CITY OF ALBUQUERQUE

Re: 4801 Lincoln Rd. NE
4801 Lincoln Rd. NE, 87109
30-Day Temporary Certificate of Occupancy
Transportation Development Final Inspection
Engineer's/Architect's Stamp dated 01-15-19 (F17D024A)
Certification dated 9-19-19

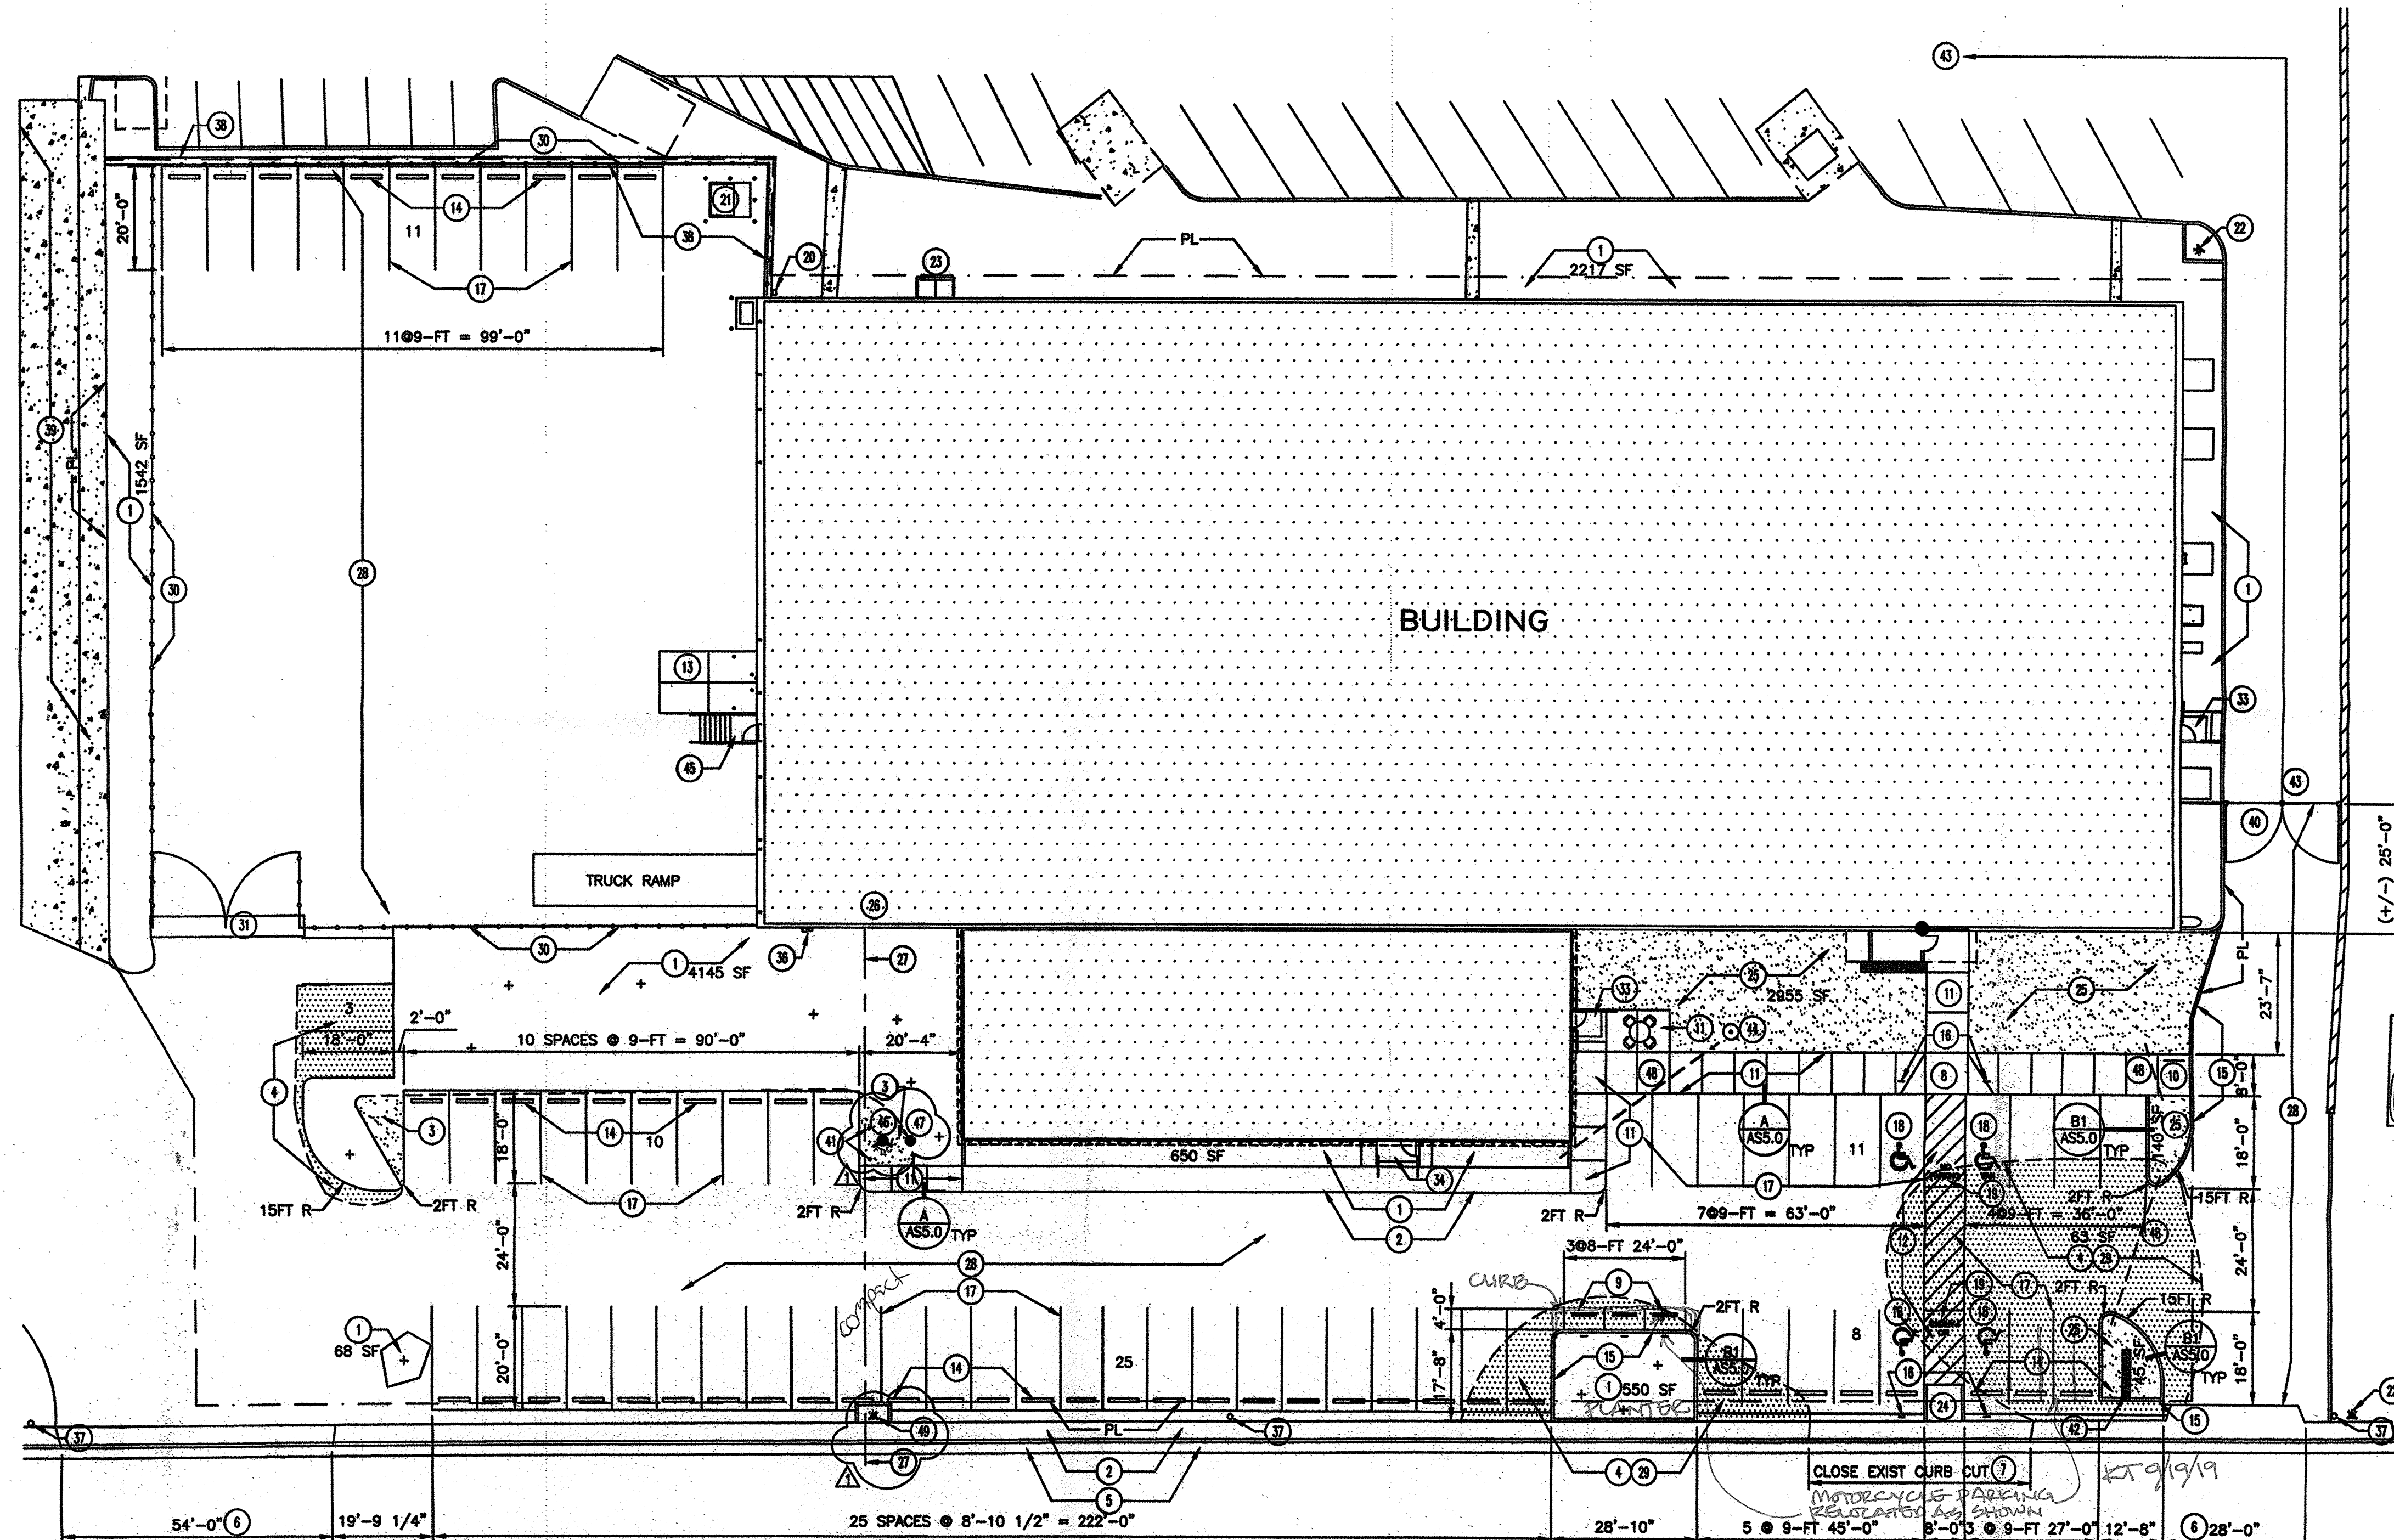
- Label the compact parking spaces by placing the words "**COMPACT**" on the pavement of each space. (Parking stall with fire hydrant. See attached photo)
- Motorcycle parking spaces shall be designated by its own conspicuously posted upright sign, either free-standing or wall mounted per the IDO. (Each stall requires its own sign)
- Please remove security fences, porta potty, construction equipment and trash container.
